Public Hearing

Jessie Drive Phase 1 Final Design and Sweetgum Access Alternative February 9, 2021

Jessie Drive Phase 1 Public Meeting Map

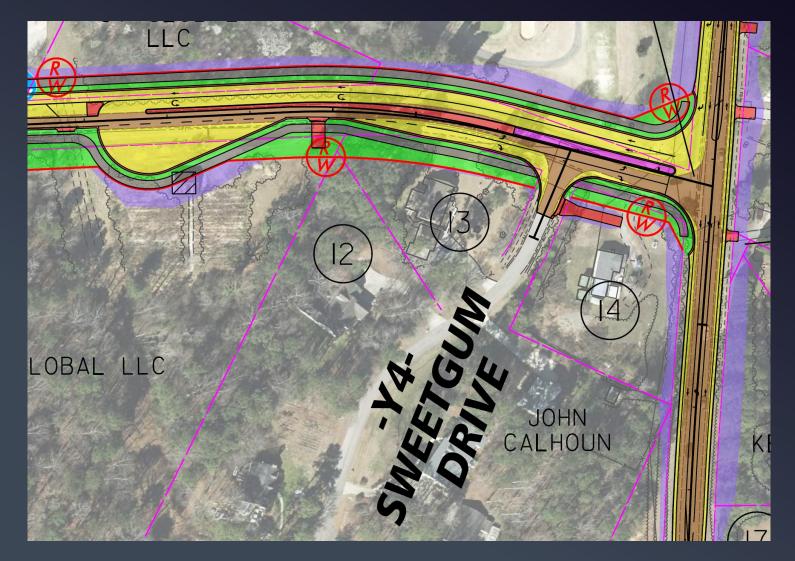
- No direct lefts in or out: Sweetgum Dr residents have to use the proposed U-turn bulb-out and U-turn at Ten Ten Rd
- Traffic waiting at Ten Ten Rd may be blocking Sweetgum Dr at peak times due to short distance and added traffic
- School bus operations and emergency access
- Sweetgum Drive has no other access (>1,700' cul-de-sac) so consider an alternative connection to Sweetgum Dr for left turn access
- Walking along & crossing Jessie Drive on foot

Sweetgum Access Alternative (proposed)

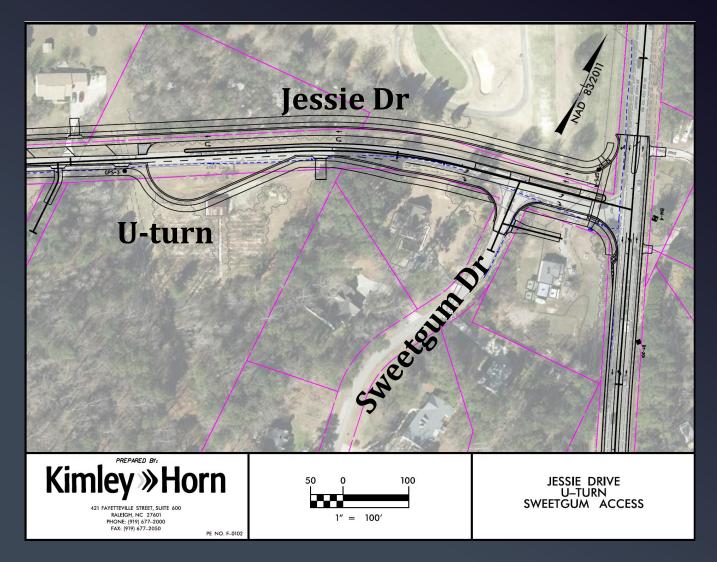
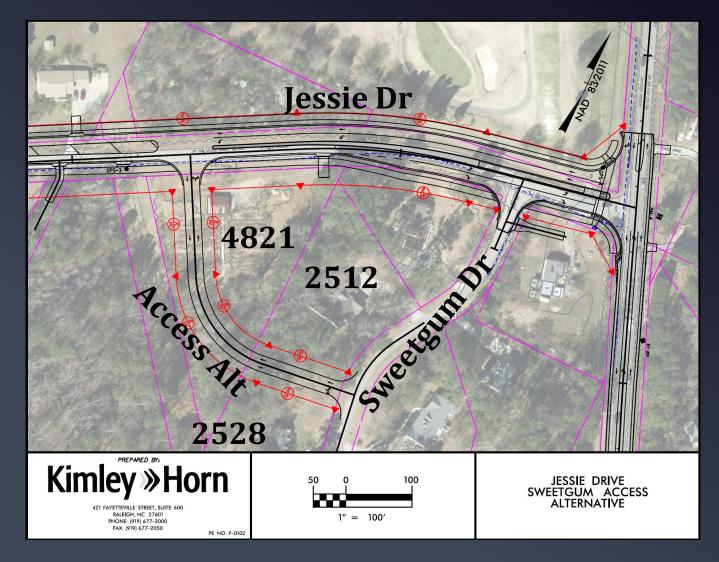
- NCDOT prefers the Sweetgum Access Alternative as presented compared to the U-turn
- Recommend a 90-degree tie-in of Sweetgum Access Alternative to Jessie Drive for improved alignment
- Recommend severing the connection of Sweetgum Drive at Jessie Drive, but <u>not required</u> for Phase 1 plan. Noted concerns about later extension to NC 55 increasing traffic volumes at Ten Ten Rd, potentially blocking Sweetgum Drive.

- Requesting public input and possible motion: Recommend modifying Jessie Drive Phase 1 final design plans to remove the proposed U-turn bulb-out and include the Sweetgum Access Alternative while keeping Sweetgum Drive connected to Jessie Drive as a rightin/right-out access as presented
- Current estimated construction cost of Phase 1 with U-turn \$3.7M (new access adds \$300,000) plus right of way acquisition
- Alternatively, staff will move forward with the U-turn bulbout if no changes to are recommended by Council, or as otherwise directed

10-foot Side Path

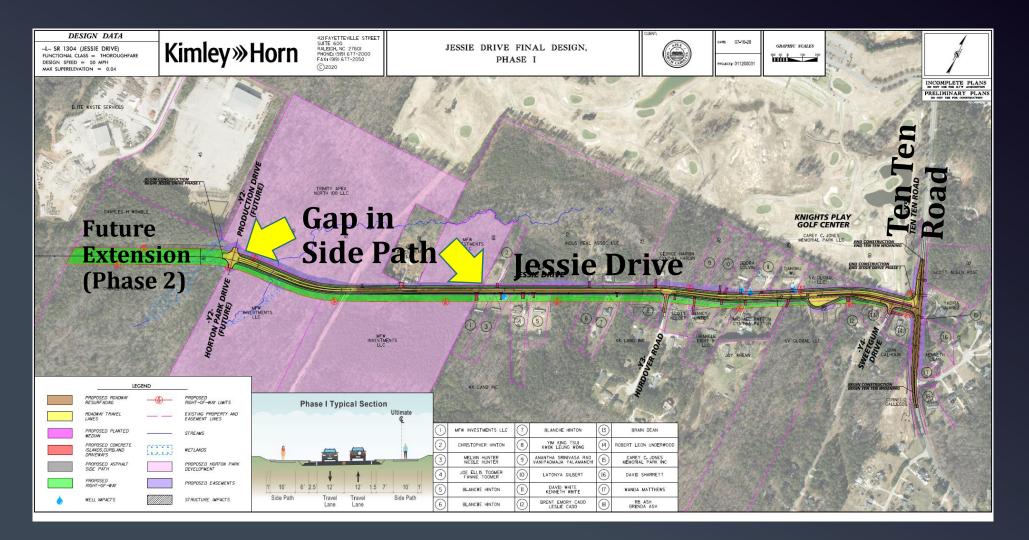
- Town's roadway plan includes 10-foot side paths on both sides of Jessie Dr
- Horton Park portion of Jessie Dr road improvements and extension includes 10-foot side path on south side of Jessie Dr only
- With the Town's roadway improvements ending at Horton park, it would leave a 1,700-foot gap in side path on the north side, while contiguous to Ten Ten Rd on south side

- Requesting public input and possible motion: Recommend continuing the 10-foot side path westward along the north side of Jessie Drive in the Phase 1 final design plans to the intersection at future Production Dr/Horton Park Dr
- Current estimated construction cost of additional side path is \$500,000 plus right of way acquisition
- Alternatively, staff will not extend the current limits of side path in Jessie Drive Phase 1 and the gap will remain until constructed as future development occurs or as part of Jessie Drive Phase 2
